# Channel Characteristics (83D.4)

Ryan Latchman, Mindspeed

Figure 83D-2— CAUI-4 chip-to-chip application

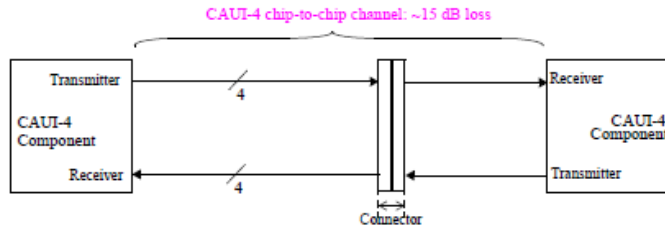
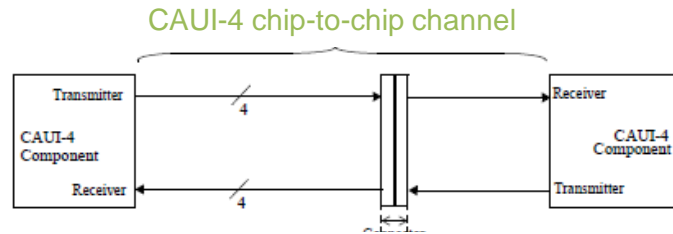
The normative channel compliance is through CAUI-4 COM as described in 83D.4. Actual channel loss could be higher or lower due to the channel ILD, return loss, and crosstalk.

Figure 83D-3—CAUI-4 chip-to-chip channel insertion loss

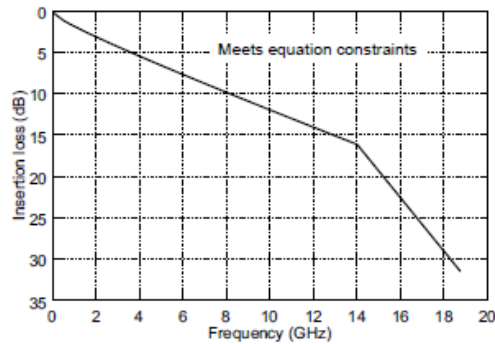
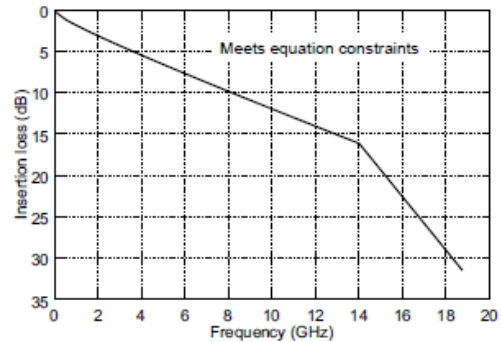
EDITORS NOTE: Insertion\_loss equation is TBD

$$Insertion\_loss(f) \leq \begin{cases} 1.614(0.075 + 0.537\sqrt{f} + 0.566f) & 0.01 \leq f < 14 \\ 1.614(-18 + 2f) & 14 \leq f < 18.75 \end{cases} \quad (\text{dB}) \quad (83D-1)$$
